Add PCD Project #
AL 21-015

**RE: Venetucci Farm / Traffic Generation and
El Paso County, Colorado**

VENETUCCI FARM
Traffic Generation Analysis

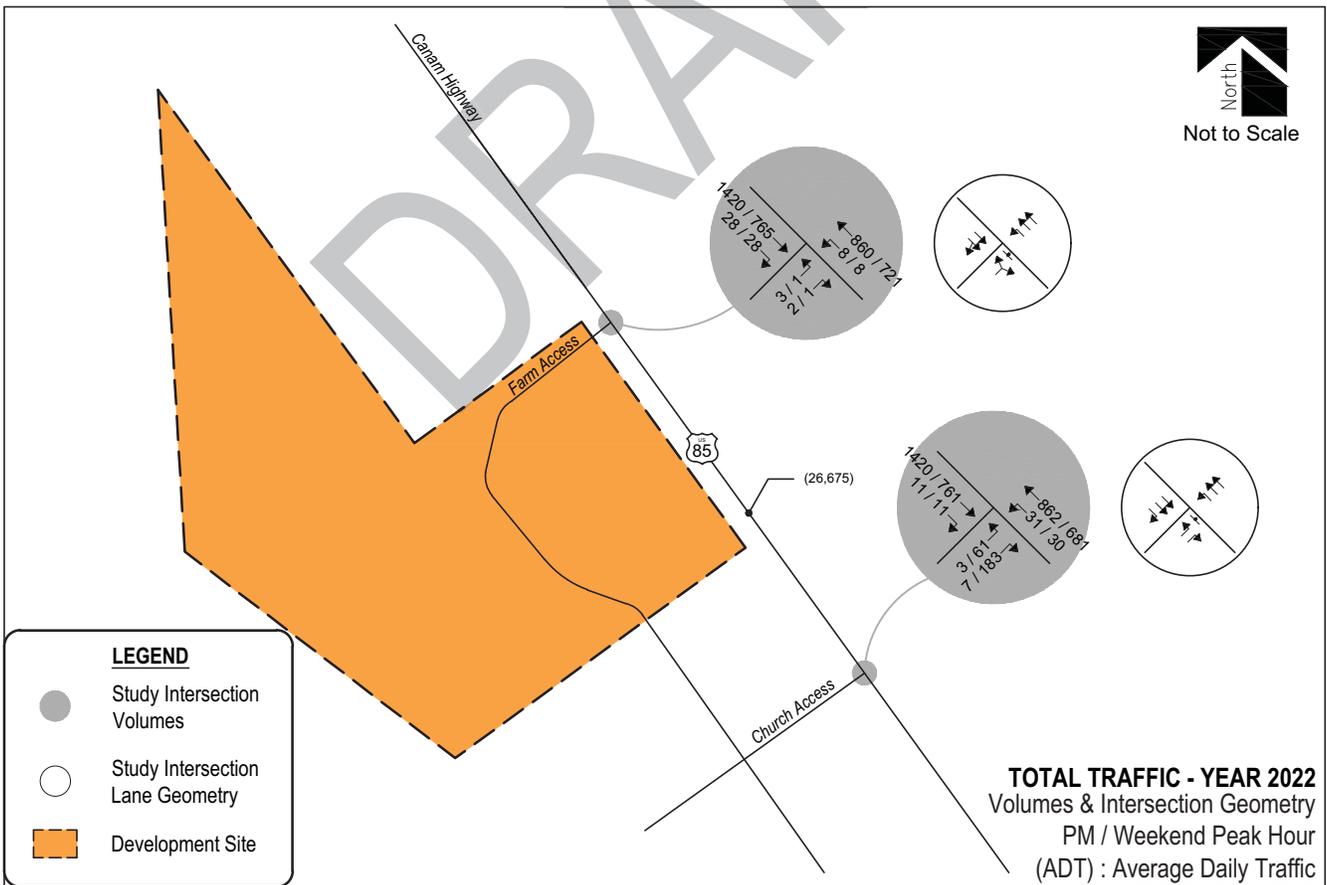
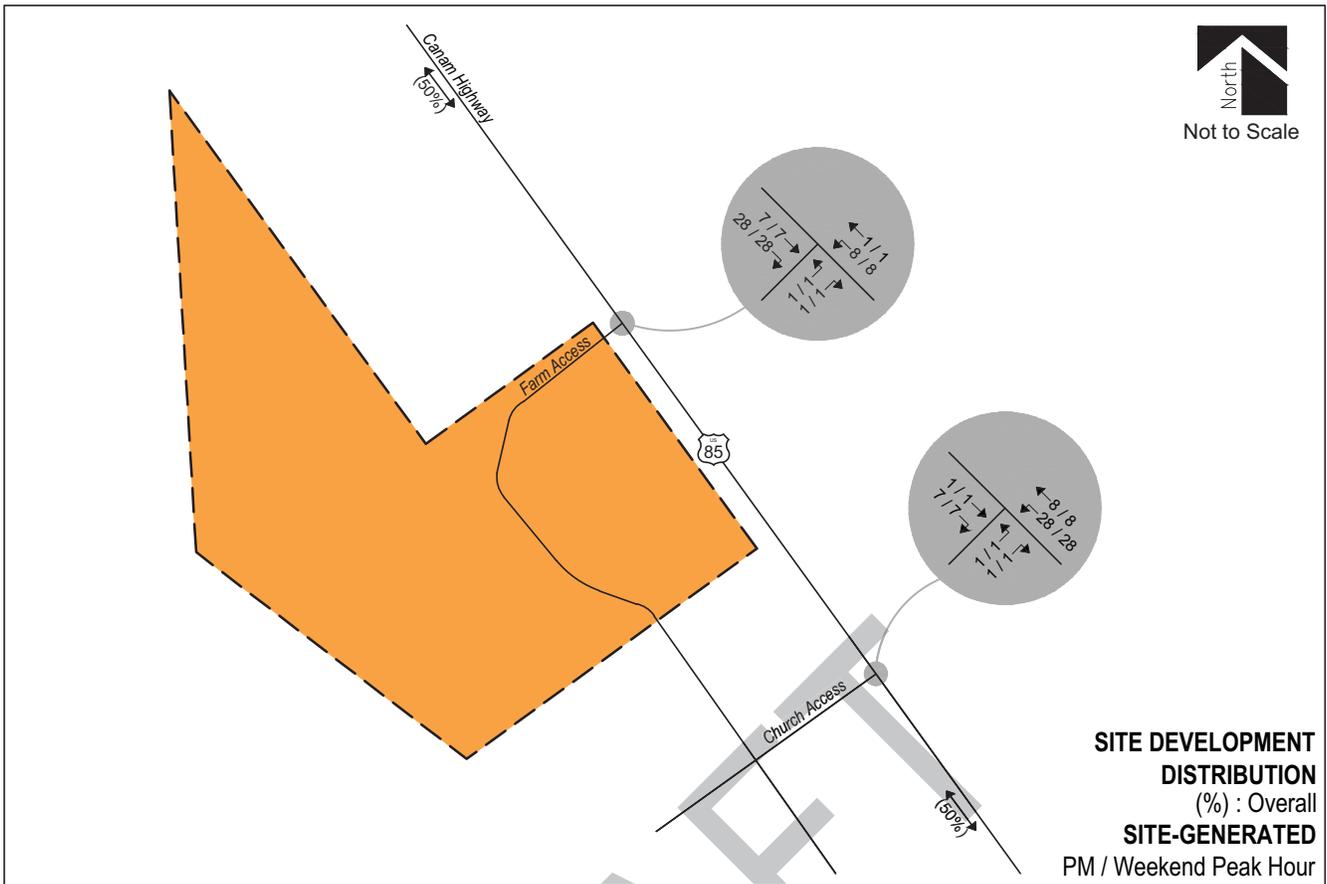
Discuss traffic impacts in the event the wedding venue occurs at the same time as church services on Sundays. It seems a worse-case scenario is having both church service and guest for the wedding venue arriving at the same time.

Text updated to provide additional detail of potential overlap scenarios. Note that with the exclusion of the Church Access from the current site plan, traffic impacts caused by overlapping peak periods of operation are expected to be minor.
